DISTRIBUTION CODE MODIFICATION PROPOSAL FORM

Modification Proposal submitted By: Séamus Power	DATE OF SUBMISSION OF PROPOSAL: 30/04/2015	Modification Proposal Number: <i>(to be assigned by Review Panel Secretary)</i> #35
CONTACT DETAILS FOR MODIFICATION PROPOSAL ORIGINATOR: (IF NOT DISTRIBUTION CODE REVIEW PANEL		
NAME: Séamus Power		TELEPHONE NUMBER: 01 2370522
E-MAIL ADDRESS:	seamus.power@eirgrid.com	
MODIFICATION PROPOSAL TITLE:	Power Factor requirements for Type C, D and Type B <5 MW WFPS connections	
DISTRIBUTION CODE SECTION(S) AFFECTED BY PROPOSAL DCC11.4.3 Power Factor		
MODIFICATION PROPOSAL DESCRIPTION <i>(Clearly state the desired amendment and all text changes. Attach further information if necessary)</i> DCC11.4.3 Power Factor WFPSs, with connection types B with a Registered Capacity of <5MW and connection types C and D shall have a settable power factor in the range of 0.92, such that vars are absorbed by the WFPS from the Distribution System , and unity, as measured at the Connection Point . This power factor range is illustrated in Figure 11. The setting shall be specified by the DSO at least 120 business days prior to the WFPS's scheduled operational date. The WFP

Figure 11

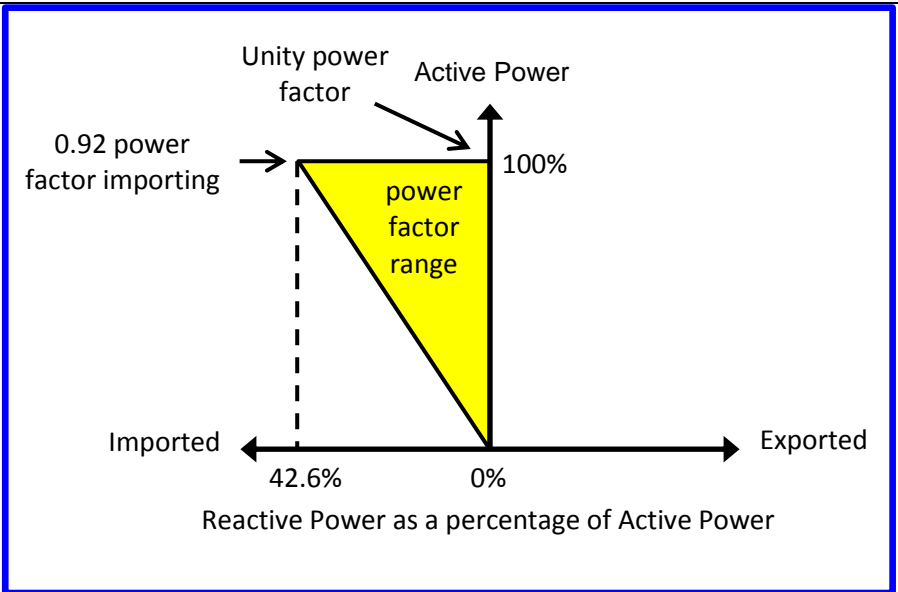
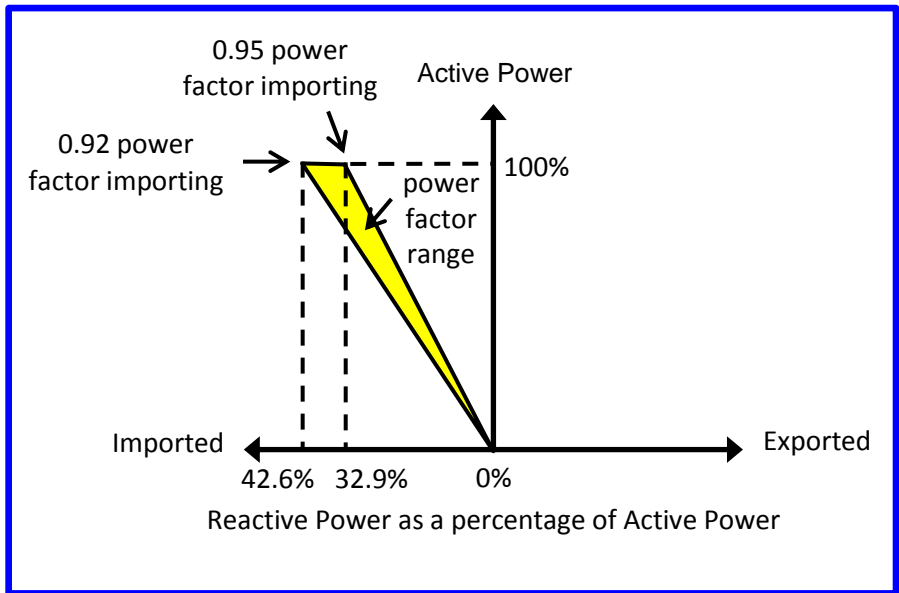
Recent studies completed by EirGrid indicate that there is a significant saving in terms of reactive compensation requirements across the transmission network if Type C- and D-connected WFPSS, whose connection method can support it, can be operated at unity power factor.
